SERVICE BULLETIN

SUBARU CORPORATION
Overseas Service Dept.
Japan.

Issued: Jan 8 2019

Subject:	Software Updates Availability: Denso-TEN (Fujitsu-TEN) Navigation & Display Radio with 7 inches screen
Applicable Section in Service Manual:	Body & Electrical/WIRING SYSTEM> ENTERTAINMENT > Audio
Applicable Parts name in Parts System:	RADIO AND NAVIGATION UNIT ASSEMBLY
Foreword:	This service bulletin is to inform you of the availability of new software to fix the following issues. SXM stations are limited to 256. Touch panel screen may not response. Quick Message may be grayout. iPhone icon in phone book is chipped.

2-1 . iPhone icon in phone book is chipped.

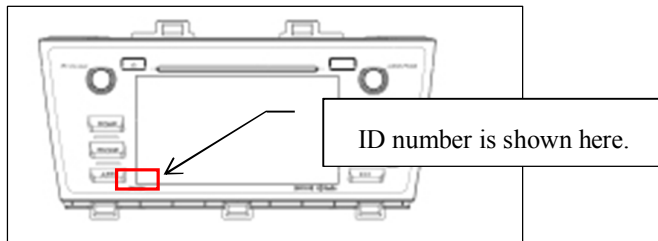
Symptom	Details of Symptom and Improvement
Some customer may have conditions following 1. DAB station number is limited and could not display all. 2. Touch panel screen may not response to touch. 3. Part of Quick Message be grayout and could not work. (Display Audio) 4. iPhone icon in phone book is chipped.	The program will fix those problems. 1. DAB stations without limit 2. Touch panel screen will be response to touch. 3. Quick Message will be fully displayed and work 4. iPhone icon will be fully displayed.
